Change Request for Diablo Canyon UFSAR Section 2.5¹

UFSAR Change Request

Living UFSAR to be Changed (check only one): <input checked="" type="checkbox"/> Living DCPD UFSAR or <input type="checkbox"/> Living DC ISFSI UFSAR	
Section(s): 2.5 (Seismology and Geology)	
Table(s): N/A	Figure(s): 2.5-33, 2.5-34, 2.5-35, 2.5-36

Summary description of the proposed change (use additional pages if required):
 UFSAR Section 2.5 (Seismology and Geology) is revised to reflect the results of the Licensing Basis Verification Project review of the Seismology and Geology section and proposed enhancements. The proposed change is being processed against UFSAR Revision 20.

FSAR UPDATE
UNITS 1 AND 2 DIABLO CANYON SITE
FIGURE 2.6-33 FREE FIELD SPECTRUM HORIZONTAL 1991 LTSP (84TH PERCENTILE NON- EXCEEDANCE) AS MODIFIED PER SSER 34

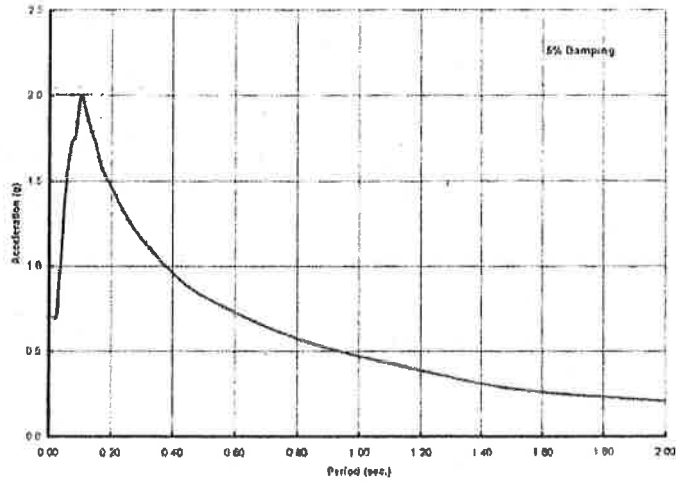
36	N/A	N/A	2.5-33	N/A	Added Figure 2.5-33 Free Field Spectra Horizontal 1991 LTSP as Modified per SSER 34	N/A	SSER 34	N/A	N/A	N/A	LEVP Enhancement to add a figure in support of enhancements to the body of section 2.5.3.10.4.	N/A	This figure is based on Figure 2.4 SSER 34. Calculation 72.2.7 details the alteration from being a frequency based plot to a period based plot. This figure is used as support for material added in AD Matrix Item # 24. These enhancements are derived from correspondence with the NRC, NRC regulatory documentation, and specific UFSAR text; therefore, a 10 CFR 50.59 Screen is not required.	No
37	N/A	N/A	2.5-34	N/A	Added Figure 2.5-34 Free Field Spectra Vertical 1991 LTSP as Modified per SSER 34	N/A	SSER 34	N/A	N/A	N/A	LEVP Enhancement to add a figure in support of enhancements to the body of section 2.5.3.10.4.	N/A	This figure is based on Figure 2.5 SSER 34. Calculation 72.2.7 details the alteration from being a frequency based plot to a period based plot. This figure is used as support for material added in AD Matrix Item # 24. These enhancements are derived from correspondence with the NRC, NRC regulatory documentation, and specific UFSAR text; therefore, a 10 CFR 50.59 Screen is not required.	No

FSAR UPDATE
UNITS 1 AND 2 DIABLO CANYON SITE
FIGURE 2.5-35 FREE FIELD SPECTRA - HORIZONTAL LTSP (PG&E 1988) GROUND MOTION VS HOSGRI (NEWMARK 1977)

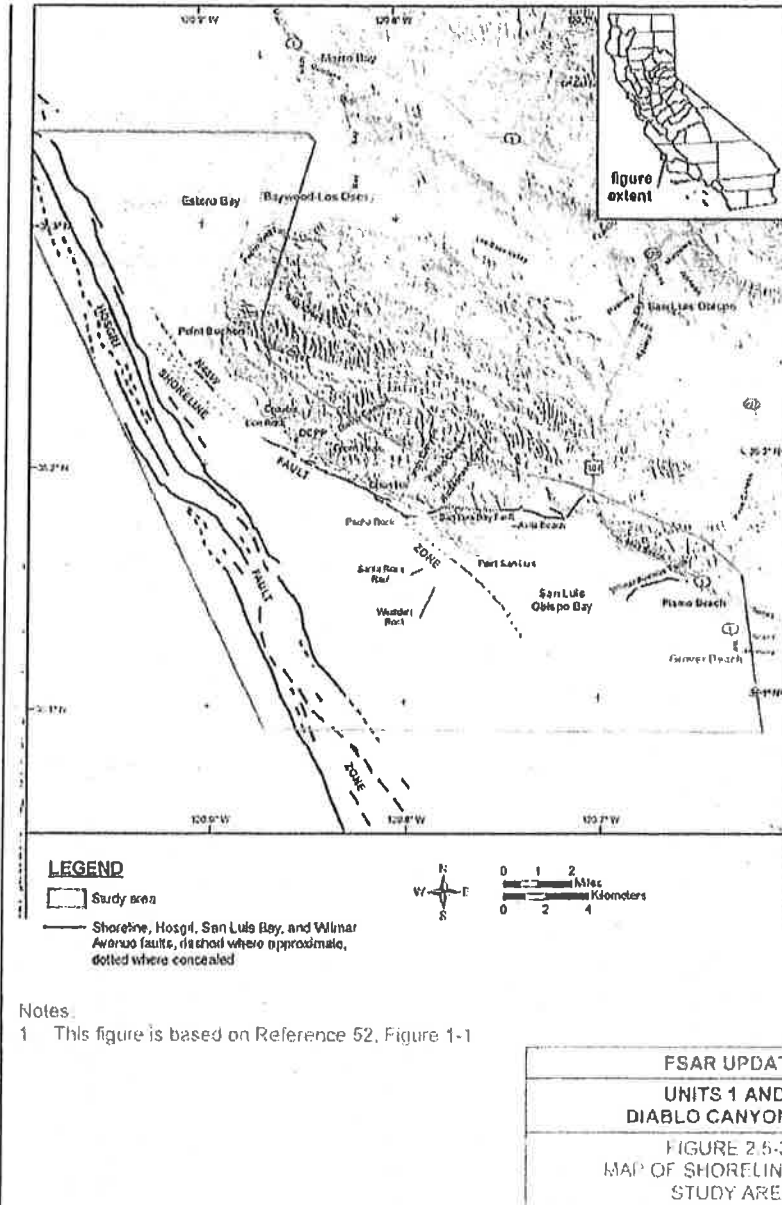
38	N/A	N/A	2.5-35	N/A	Added Figure 2.5-35 Free Field Spectra - Horizontal LTSP (PG&E 1988) Ground Motion vs. Hoop (Newmark 1977)	N/A	N/A	N/A	N/A	N/A	LEVP Enhancement to add a figure in support of enhancements to the body of section 2.5.3.10.4.	N/A	This figure is based on Figure 7-2 of the Final Report of the Diablo Canyon Long Term Seismic Program, July 1988, adjusted as stated in SSER 34. This figure is used as support for material added in AD Matrix Item # 24. These enhancements are derived from correspondence with the NRC, NRC regulatory documentation, and specific UFSAR text; therefore, a 10 CFR 50.59 Screen is not required.	No
39	N/A	N/A	2.5-36	N/A	Added Figure 2.5-36 Map of Shoreline Fault Study Area	N/A	N/A	N/A	N/A	N/A	LEVP Enhancement to add a figure in support of enhancements to the body of section 2.5.7.1.	N/A	This figure is based on Figure 7-1 of the Report on the Analysis of the Shoreline Fault Zone - Central Coastal California, January 2011. This figure is used as support for material added in AD Matrix Item #29. These enhancements are derived from correspondence with the NRC, NRC regulatory documentation, and specific UFSAR text; therefore, a 10 CFR 50.59 Screen is not required.	No
